TIMCO ENGINEERING INC.

Subject : Correspondence of your question. Job # 2591KC5
FCC ID: BEJL1970HN

Main Board Block Diagram (Before)

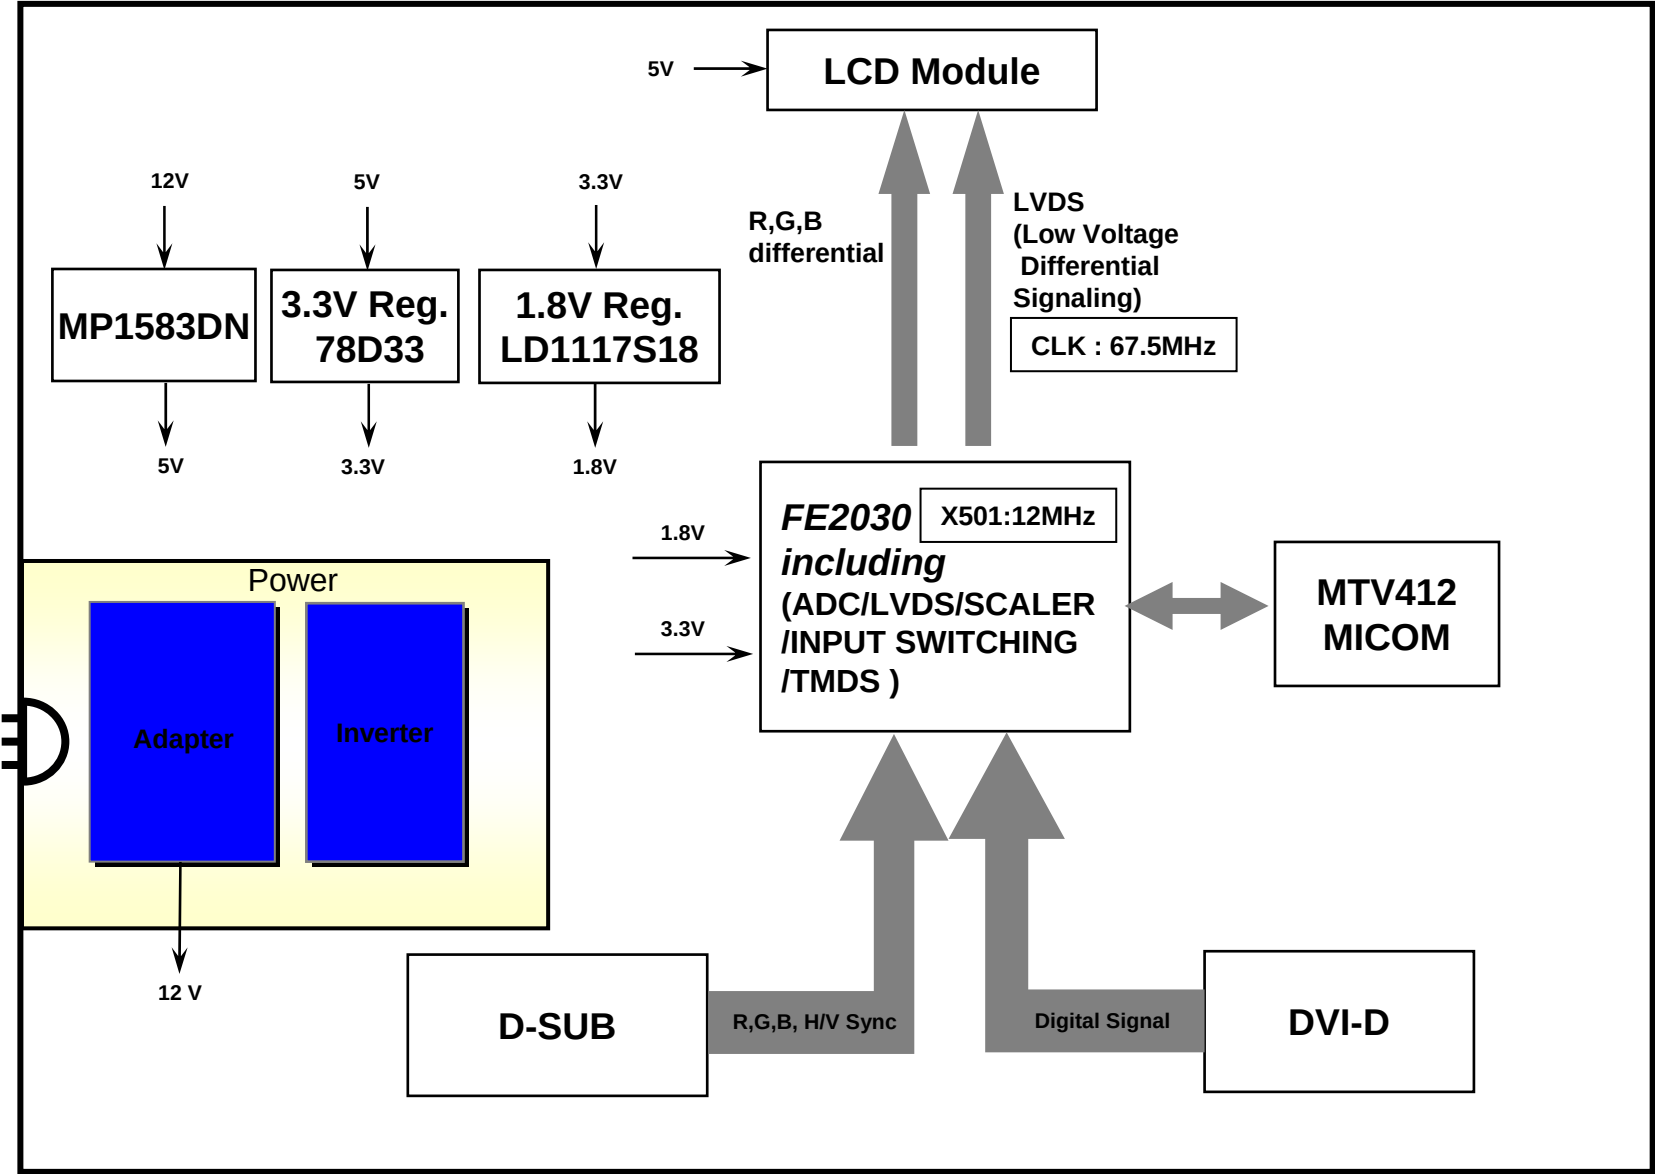
- The purpose of change is upgrading the picture performance. The response time of LCD picture is from 8ms to 4ms. The below parts are added or changed to make upgrading the visual performance.
 - Changed Scaler IC : TSU56AWL
 - Added SDRAM 16M
 - Added ODC(overdrive circuit) IC: NVI S5001
- ➔ The main function (i.e. Resolution timing table, Data clock frequency, VCC Power) is exactly same with originals. Therefore, I believe it can comply with FCC regulation Part 2.1043 and to be treated Class II permissive change.
- The applicant fully understands the Grant note 24 and 28. It's not problem to put the Grant note on the Grant of Class II permissive Change
